HONDA

Confirmation of EU stage 5 changes done to GX160UT2 engine

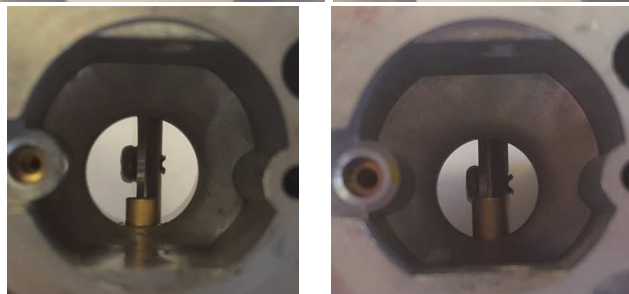
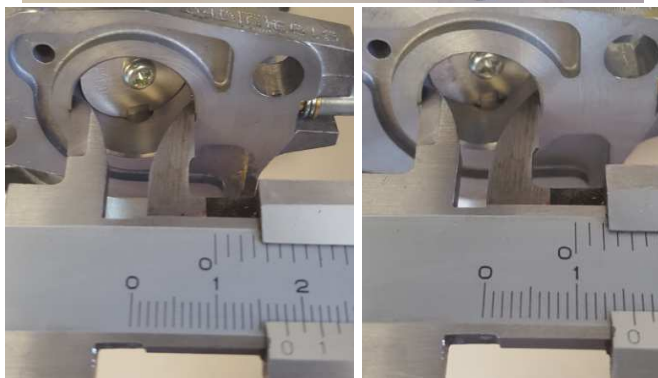
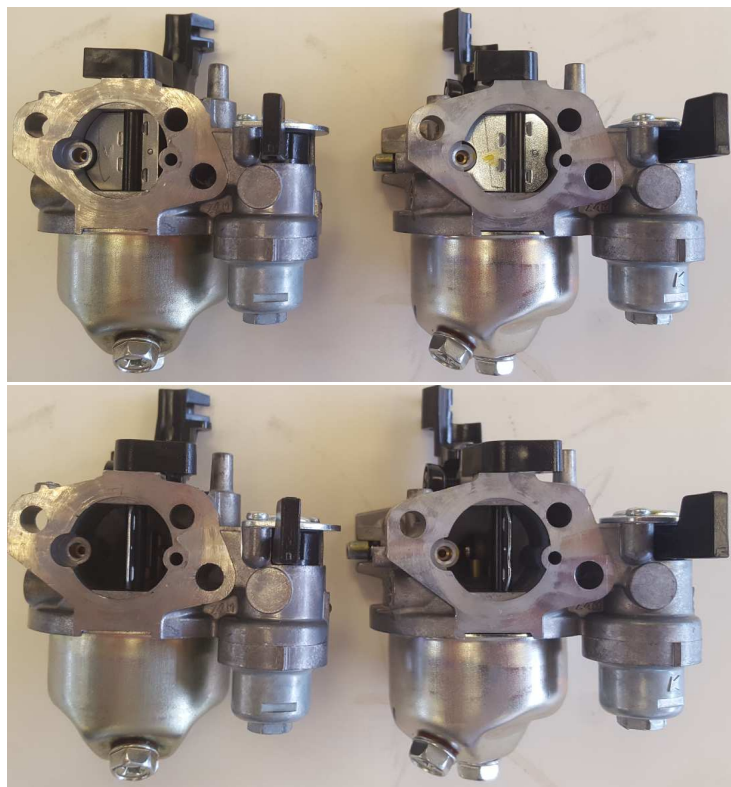
Carburetor spec change :
Venturi
Emulsion tube
Throttle valve

Mass production
engine GX160UT2
QX4 part

EU stage 5 sample
engine GX160UT2
QX4 part

Mass production engine GX160UT2 QX4 part EU stage 5 sample engine GX160UT2 QX4 part
